## Addendum NO 1

**ISSUED BY:** Great River Engineering

**DATE:** April 15, 2021

FOR: Barton County BRO-B006(21)

# WATER GAP DETAIL

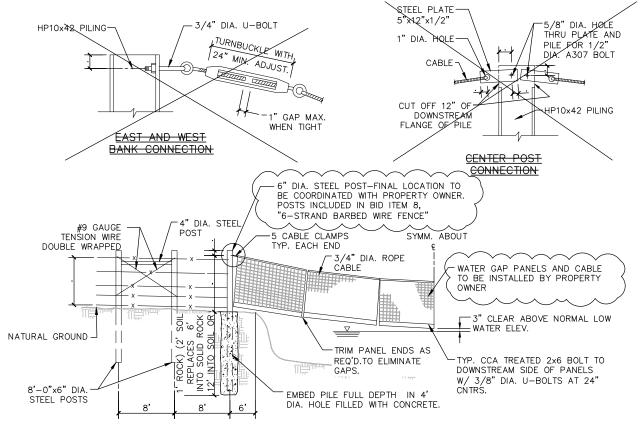
**Sheet C3-** Water gap details have been updated on this sheet.

**Question:** Is it the responsibility of the contractor to install the 10x42 HP as shown and is that work subsidiary to the Bid Item new 6-Strand Barbed Wire Fence?

**Answer:** See updated Sheet C3 for details. Contractor to install water gap posts (6" diameter steel posts) and property owner is to install final cable and panels. 6" steel posts and installation are considered subsidiary to Bid Item 8, "6-Strand Barbed Wire Fence".

BRIDGE #0300009 GENERAL NOTES B006(21) NW 45th LANE BRIDGE #C BARTON COUNTY, MISSOURI ∞ QUANTITIES ESTIMATED RO-

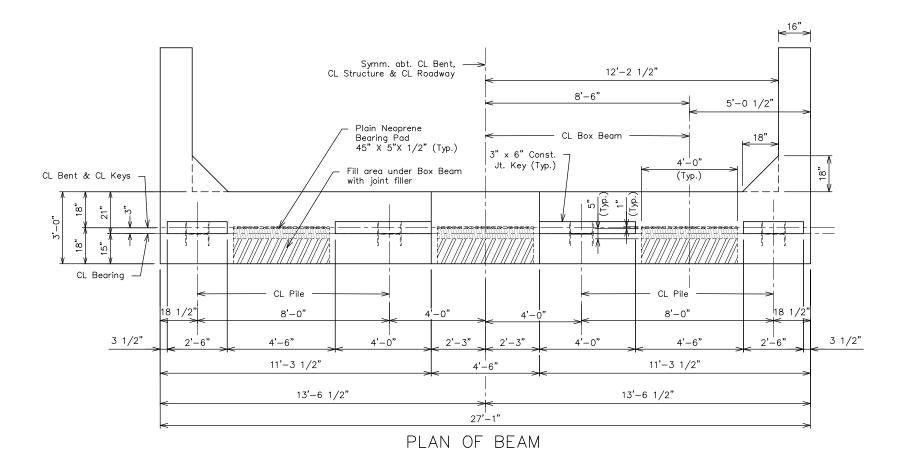
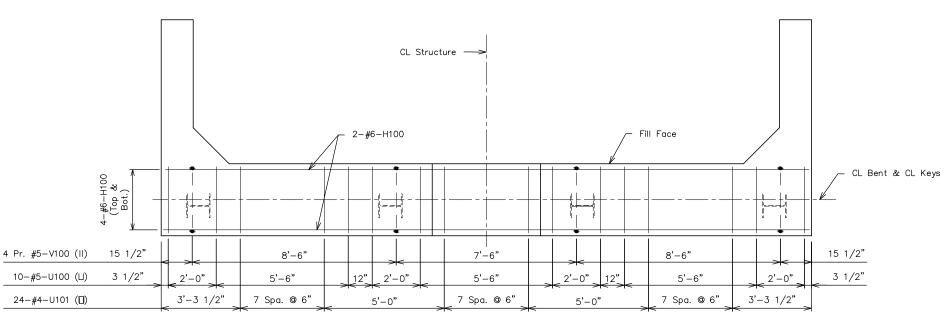
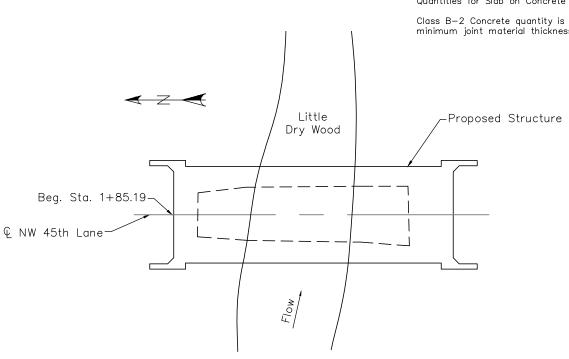
**Sheet S2-** Reinforcing Steel quantities have been updated and a note was removed.

BRO-B006(21) NW 45th LANE BRIDGE #03000091 BARTON COUNTY, MISSOURI DETAILS OF END BENT NO.1

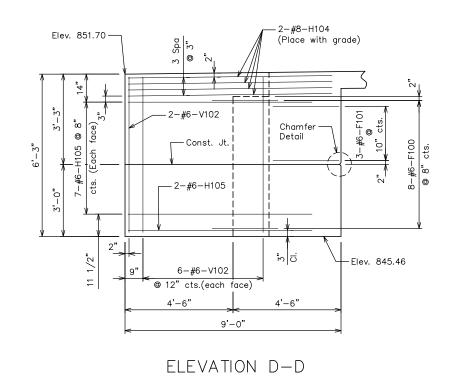
**Sheet S3**- Reinforcing Steel (Bridges) quantity has been updated.

JEFFREY A. BANDERET, JR. - ENGINE MO# PE-2017030568 BRO-B006(21) NW 45th LANE BRIDGE #03000091 BARTON COUNTY, MISSOURI DETAILS OF END BENT NO. DRAWN BY: KFB JOB NUMBER: 4152 FILE NAME: 4152\_STRUCTURA SCALE: NO SCALE
ISSUE DATE: FEBRUARY, 202:
SHEET NUMBER: S<sub>5</sub>

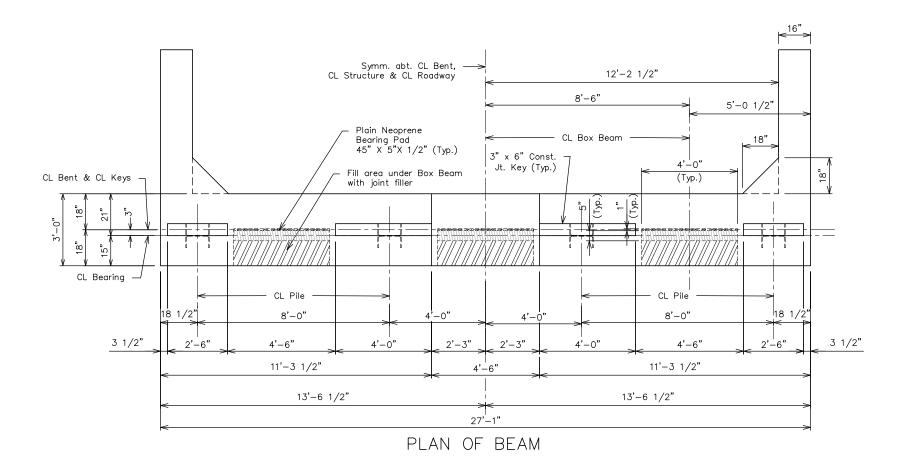
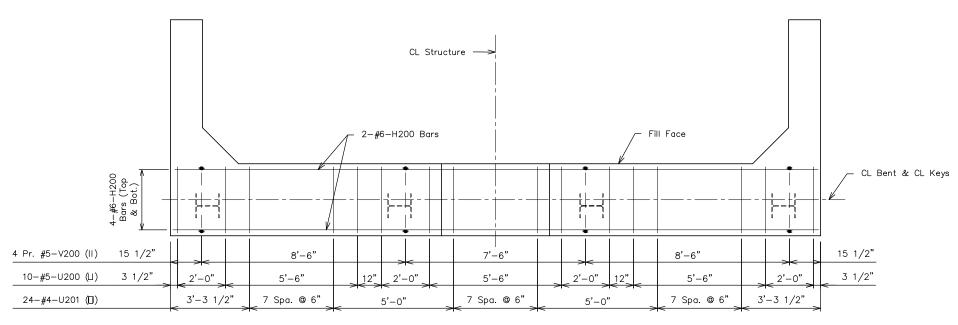
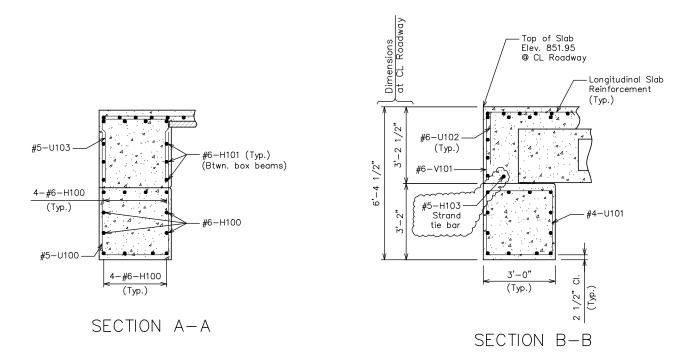
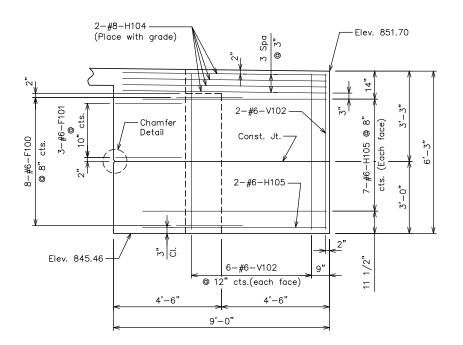
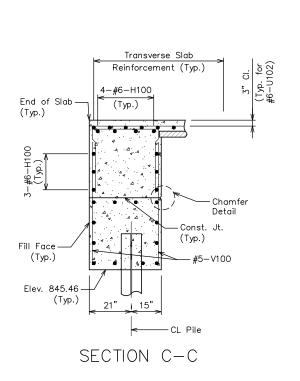
Sheet S5- A leader has been added to Section B-B showing location of H103 steel.

BRO-B006(21) NW 45th LANE BRIDGE #03000991 BARTON COUNTY, MISSOURI DETAILS OF END BENT NO. 2

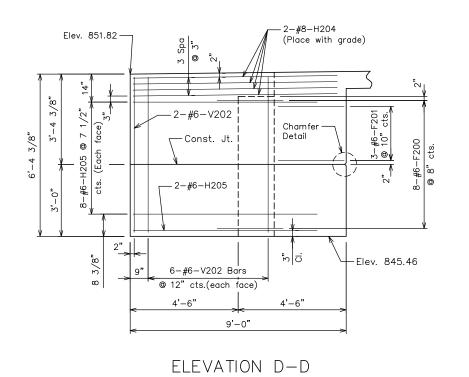
**Sheet S6-** Reinforcing Steel (Bridges) quantity has been updated.

GREAT RIVER JEFFREY A. BANDERET, JR. - ENGINE MO# PE-2017030568 BRO-B006(21) NW 45th LANE BRIDGE #03000091 BARTON COUNTY, MISSOURI DETAILS OF END BENT NO. 2

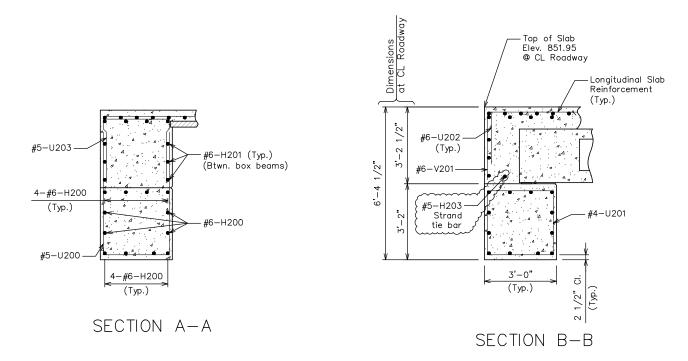
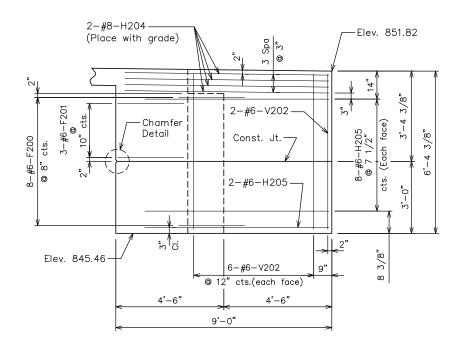
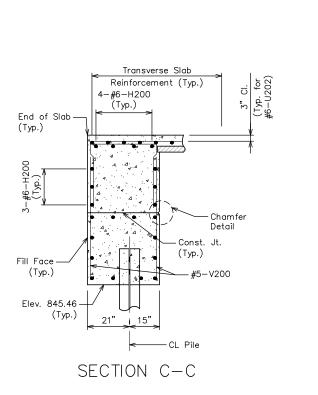
**Sheet S8-** A leader has been added to Section B-B showing location of H103 steel.

**S**15

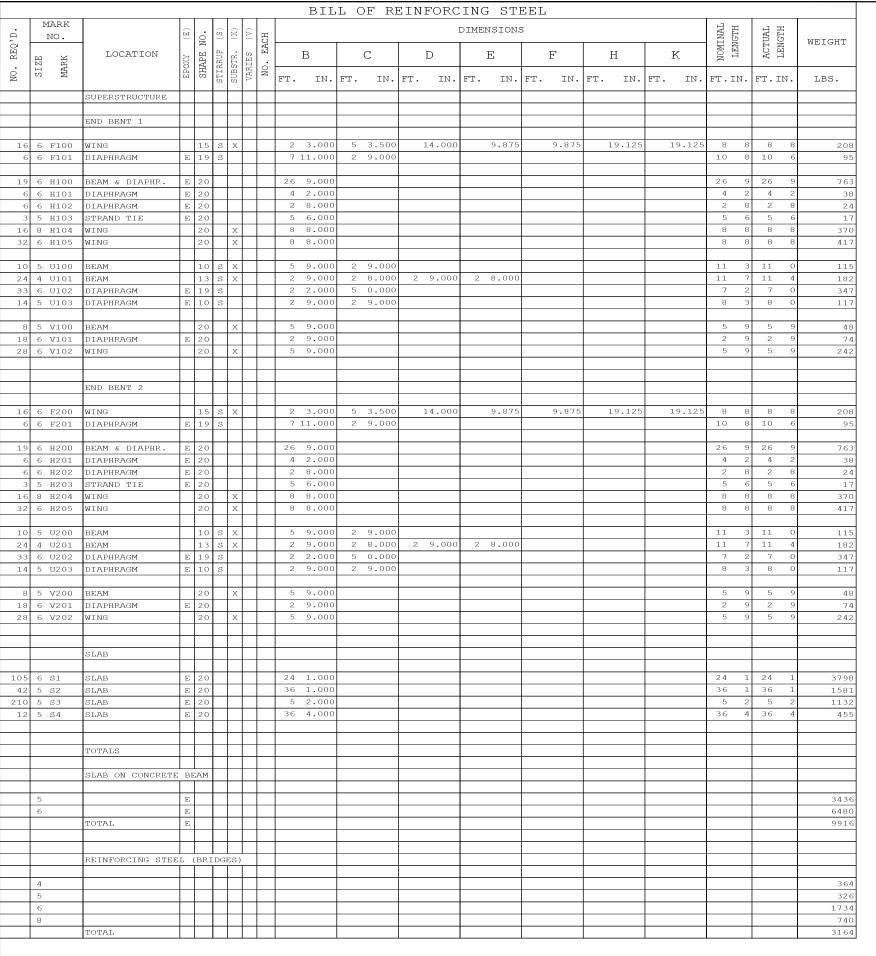
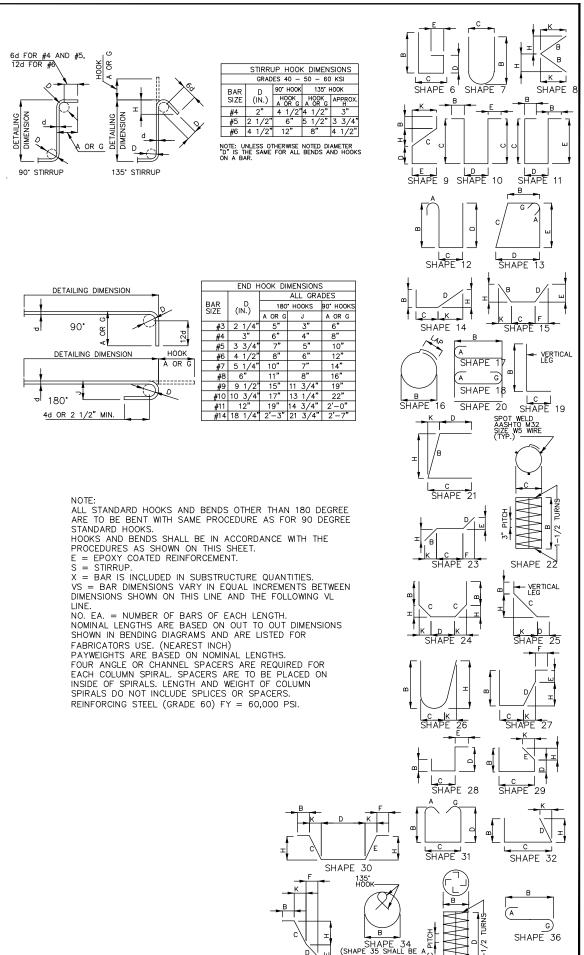
**Sheet S15-** Bill of Reinforcing has been updated to reflect black steel in substructure and exclude slab steel from REINFORCING STEEL (BRIDGES) quantity.
